SUBJECT: Forwards comparison of draft STS w/snubber functional test sampling plan.

Re: Snubber Functional Test
Sampling Plan

SNUBBER FUNCTIONAL TEST
SAMPLING PLAN EVALUATION

Probability of Testing Exactly a Given Number

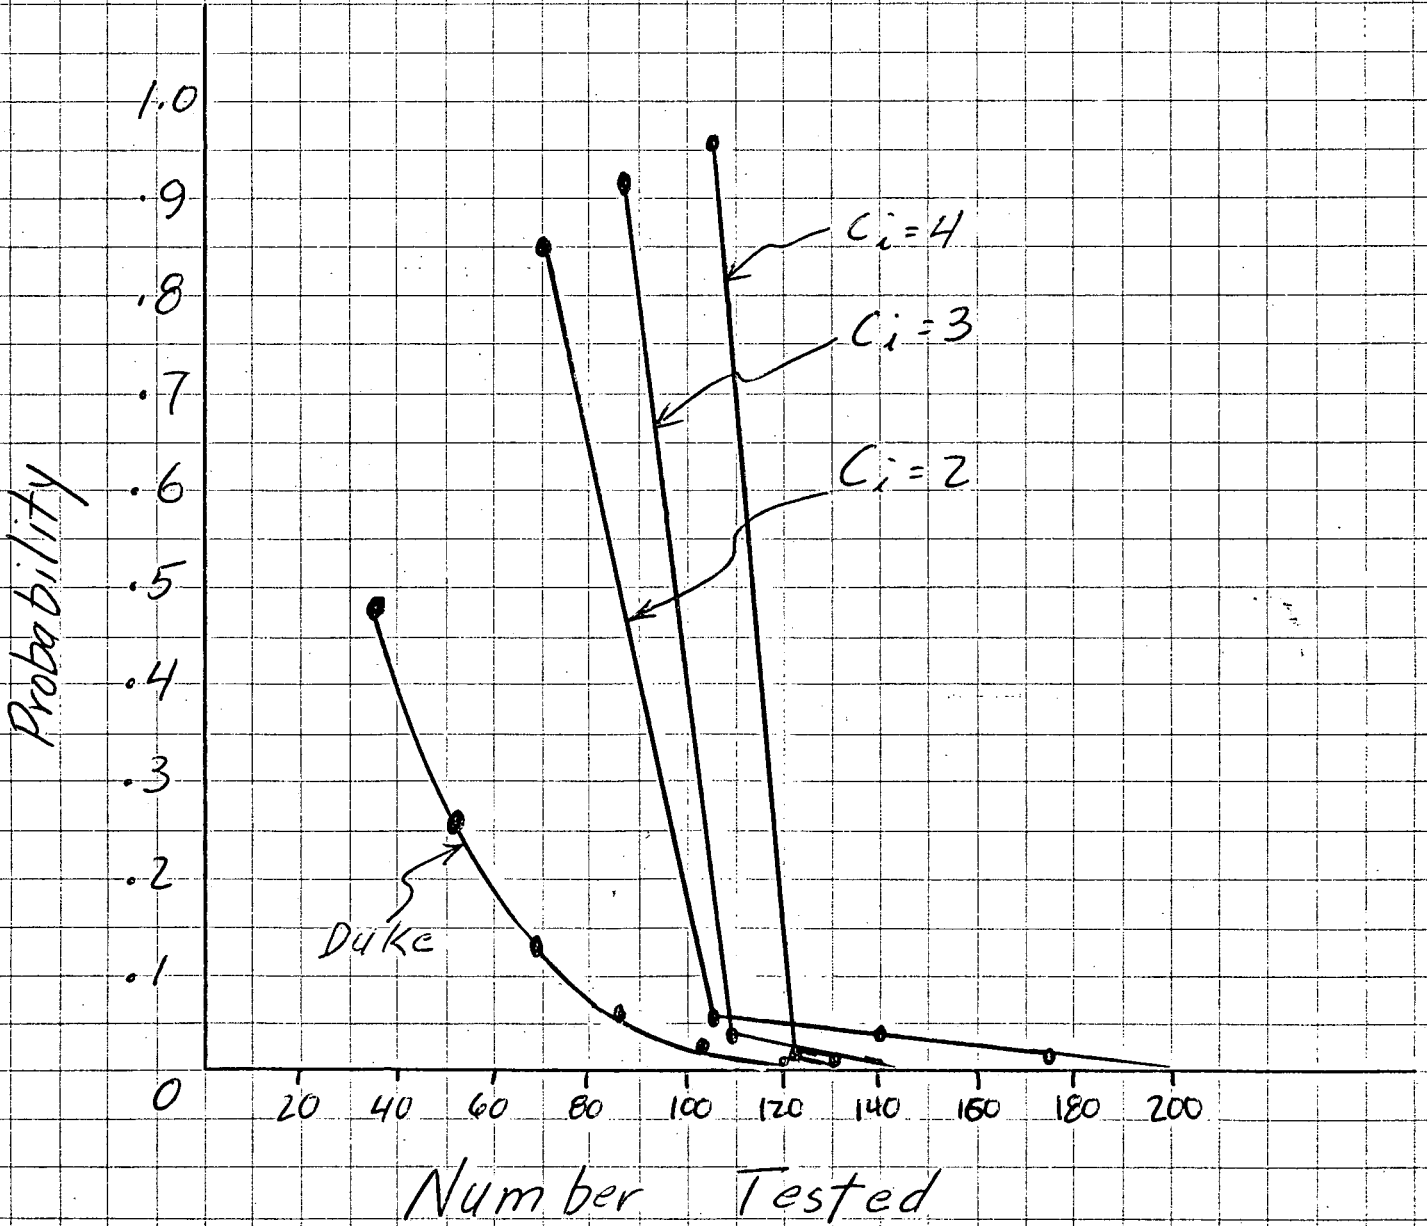
Figure 5 shows the probability of testing exactly a given number for each plan under consideration. Using this information, Figure 6 has been developed which shows the expected average number of snubbers tested 96 per cent of the time. The remaining four per cent are those low probability cases requiring a large amount of testing. As can be seen from Figure 6, the Duke plan will average 48 snubbers tested while the draft plans require averages of 73, 84, and 105 respectively.

Expected Average Number Tested 96% of the Time

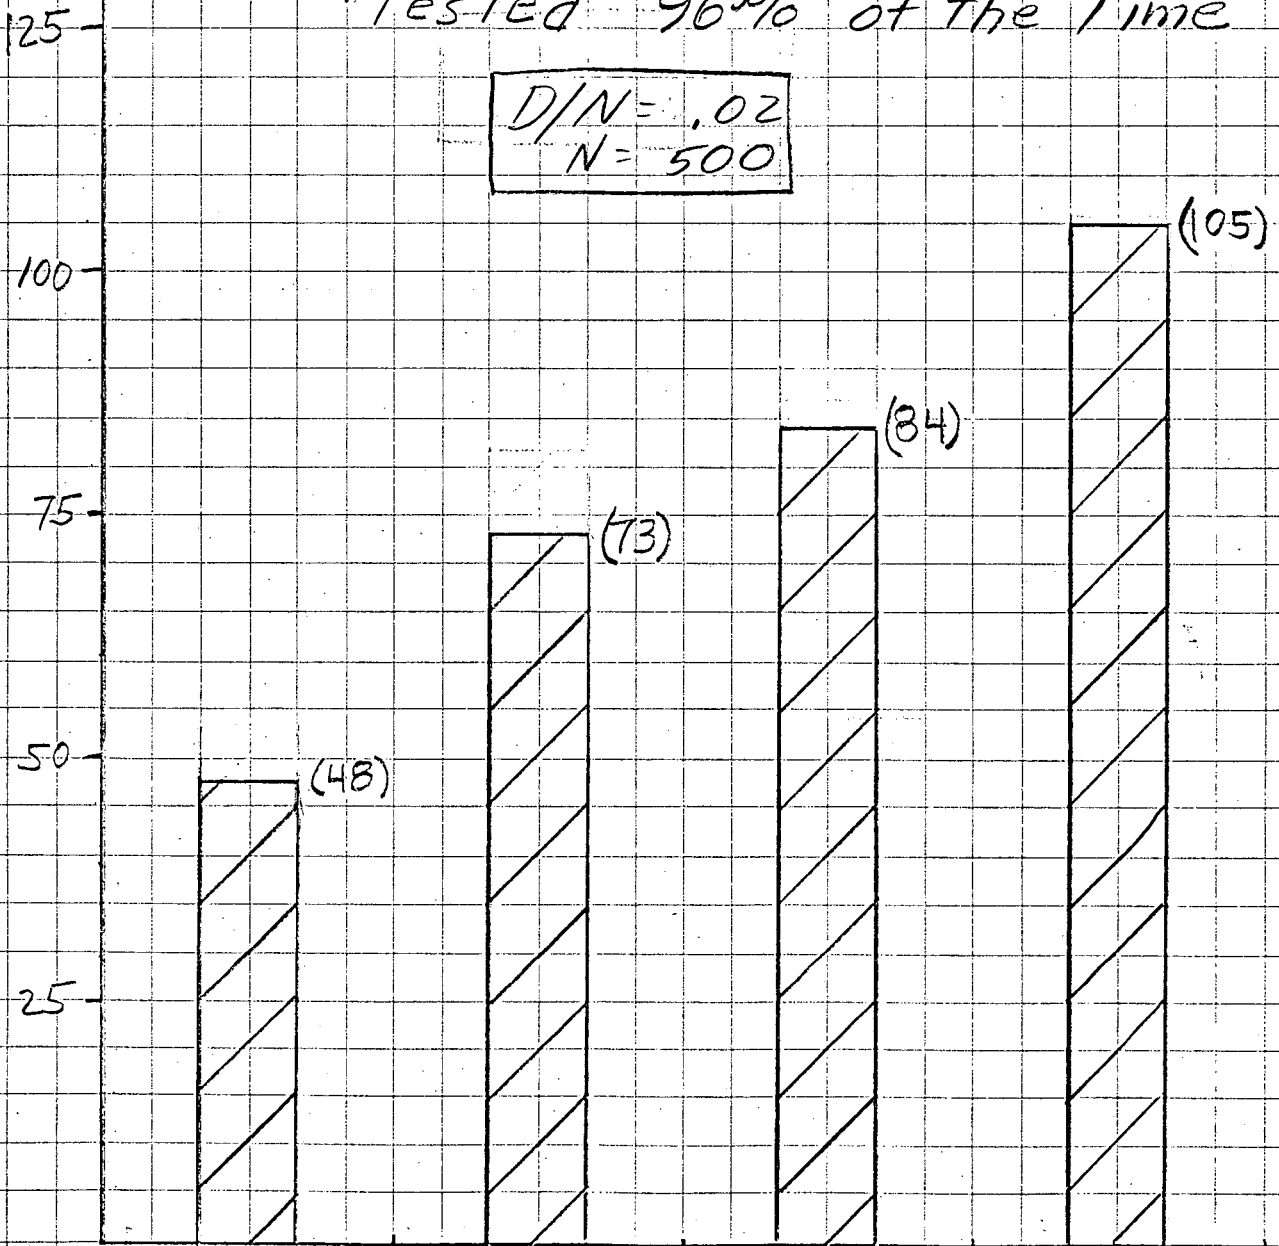
Our conclusion is that the Duke plan is considerably more effective than all of the draft plans in minimizing costs.
